Vibro Champ Reverb MkII	
Circuit Diagram	bja 04-05-2018
SE-Guit Amp w Reverb & Tremolo	
Steven Puddnhaid Husting	
Rev 1.0	Sheet 1 of 1

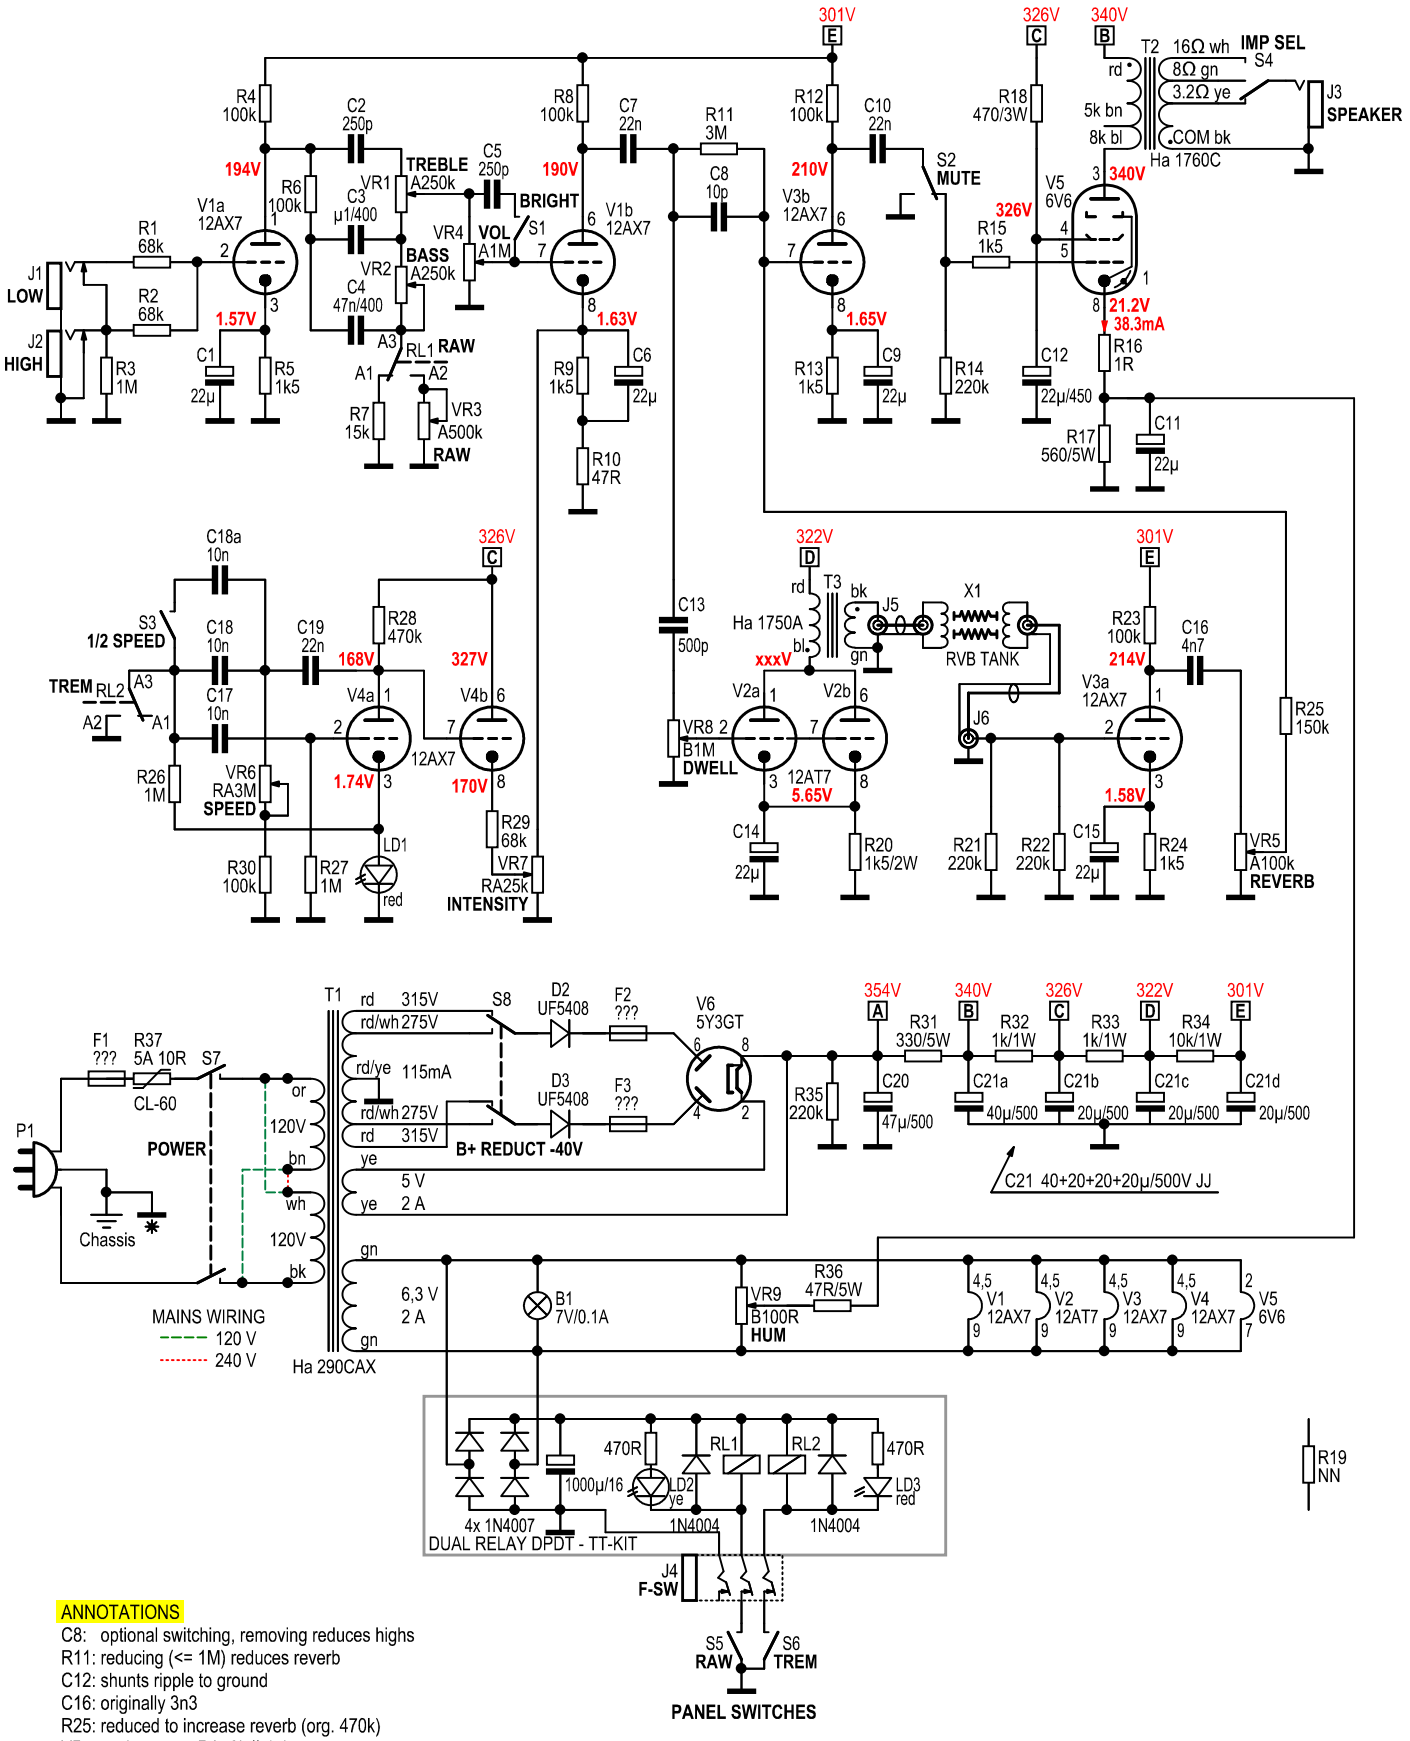
C8: optional switching, removing reduces highs
R11: reducing (<= 1M) reduces reverb
C12: shunts ripple to ground
C16: originally 3n3
R25: reduced to increase reverb (org. 470k)
VR7: replacement RA50k || 47k
T1: alternate wiring for 120 V or 240 V AC input
J4: Foot switch uses dual relay DPDT kit from Tube Town

- wrong pin numbers on tubes
- Voltages on V4a and V4b are reversed
- DWELL: upper lug and wiper are shorted

R21, R22: both resistors? Layout plan shows only 1 resistor
F1, F2, F3: Values?
VR8 (DWELL): Layout plan shows A250k instead of B1M
X1: Reverb Tank Type?
